AGENDA

July 20, 2023 Standards Committee Meeting

RE: Agenda for the July 20, 2023 Standards Committee Meeting

C. STANDARD SPECIFICATIONS, SPECIAL PROVISIONS, AND STANDARD DRAWINGS PROPOSAL

801.03 General Requirements
 801.10 Temporary Traffic Barriers
 801.10.1 Construction Zone Energy Absorbing Terminal, CZ
 E 801-TCCB-01 TEMPORARY CONCRETE BARRIER INDEX SHEET (WITH MARKUPS)

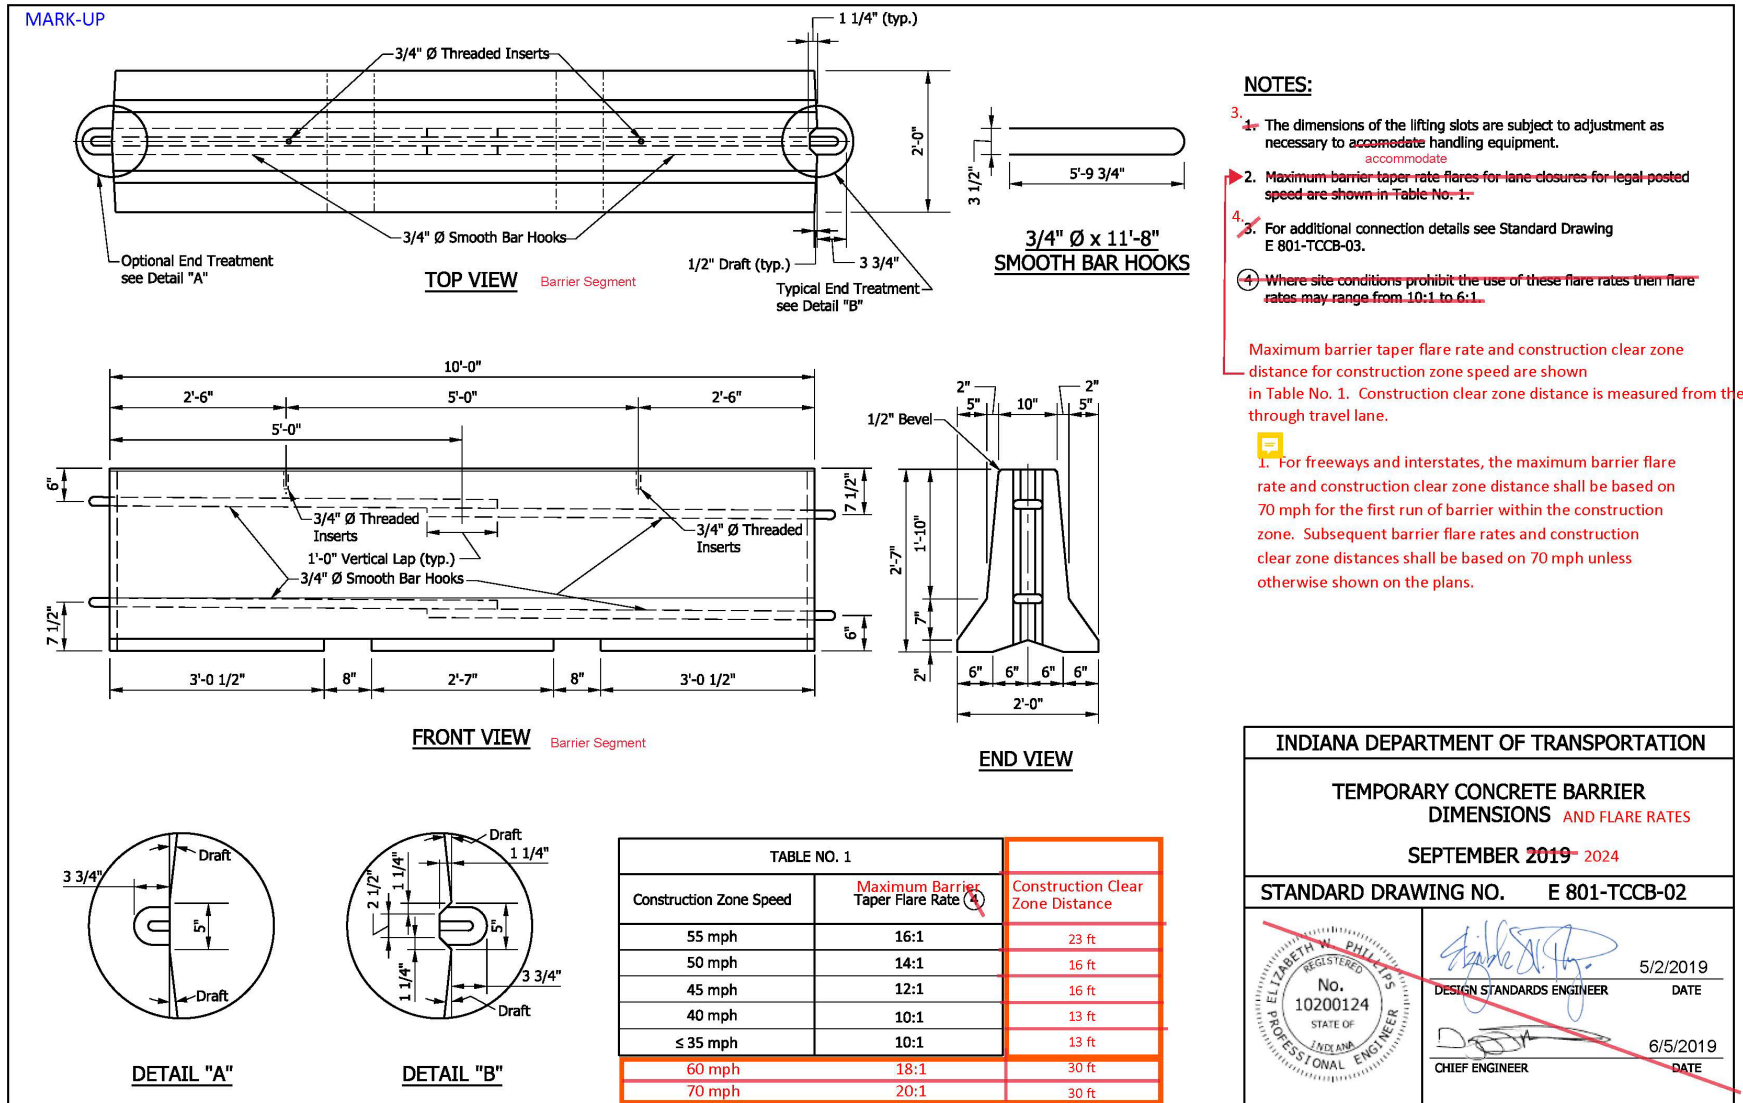
MARK-UP Editorial change to index this sheet

INDIANA DEPARTMENT OF TRANSPORTATION	
TEMPORARY CONCRETE BARRIER DETAILS	
SEPTEMBER 2019	
STANDARD DRAWING NO.	E 801-TCCB-03
	 DESIGN STANDARDS ENGINEER 5/2/2019 DATE
	 CHIEF ENGINEER 6/5/2019 DATE

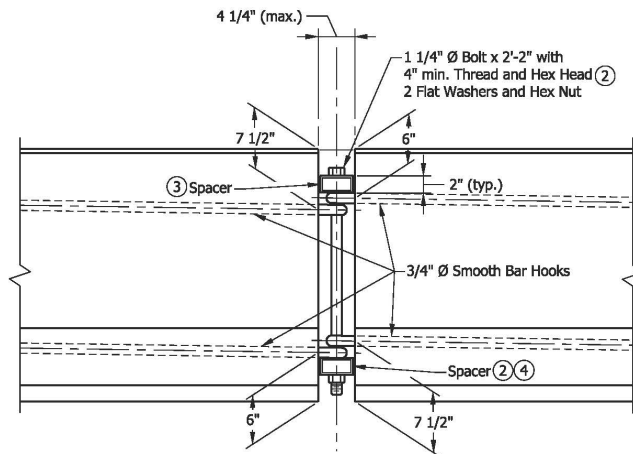
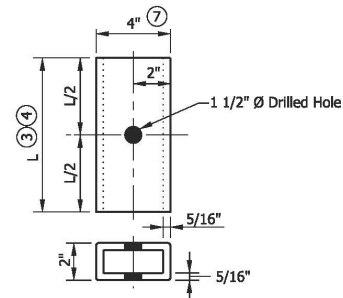
MARK-UP editorial change to note 8 this sheet

8. In lieu of the connection detail shown, the J-J Hook temporary barrier connection of Easi-Set Industries as described in FHWA **acceptance** letter B-52 of March 26, 1999 may be used. **eligibility**

8. In lieu of the connection detail shown, the J-J Hook temporary barrier connection of Easi-Set Industries as described in FHWA eligibility letter B-52 of March 26, 1999 may be used.

E 609-BRJT-01 TYPE I-A JOINT (WITH MARKUPS)

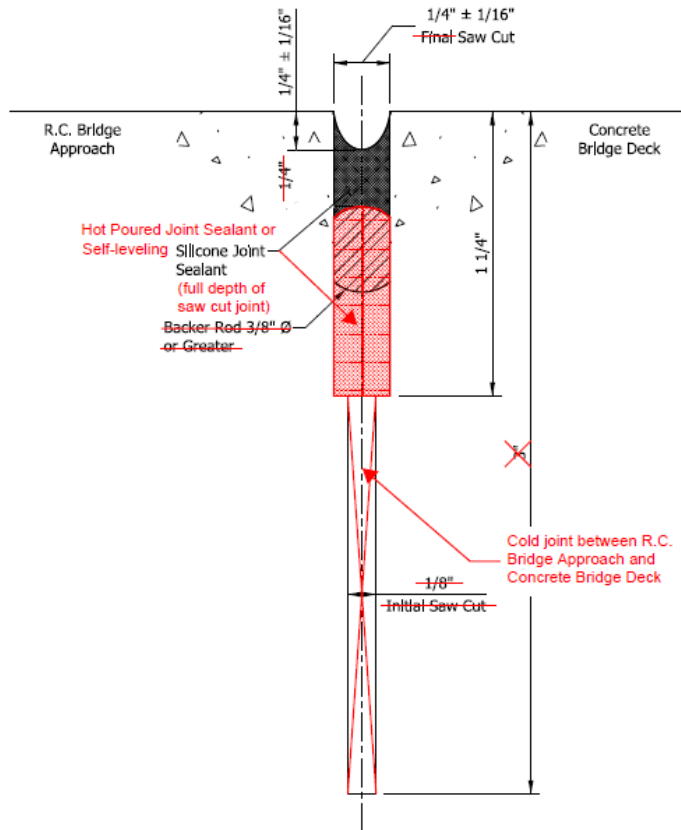
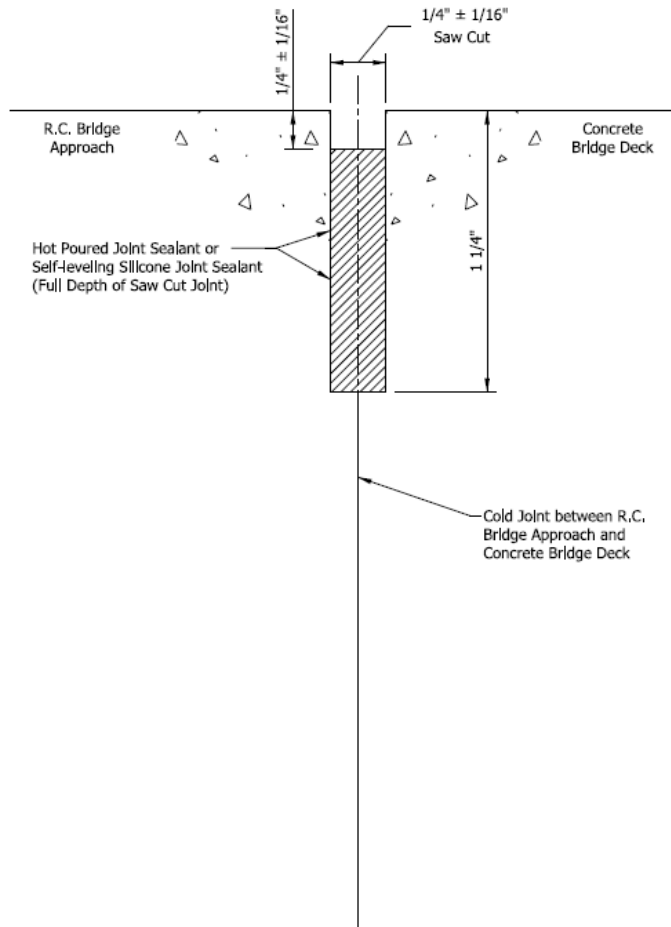
PROBLEM(S) ENCOUNTERED: The current detail for Type I-A joints includes a backer rod to limit the depth of silicone sealant to the upper ½ in. of the joint, leaving the remaining depth open. Research has shown that this creates a space for moisture to enter once the sealant breaks down, causing the space below the sealant to experience more rapid deterioration of the concrete.

PROPOSED SOLUTION: Similar to the current joint details for concrete pavement shown in Standard Drawing series E 503-CCPJ, the backer rod will be eliminated and the saw cut joint will be completely filled with either silicone or hot poured sealant. The Type I-A joint will also be revised to a single saw cut rather than the current two phase cut to facilitate the complete filling of the joint and simplify construction.

E 609-BRJT-01 TYPE I-A JOINT (PROPOSED DRAFT)
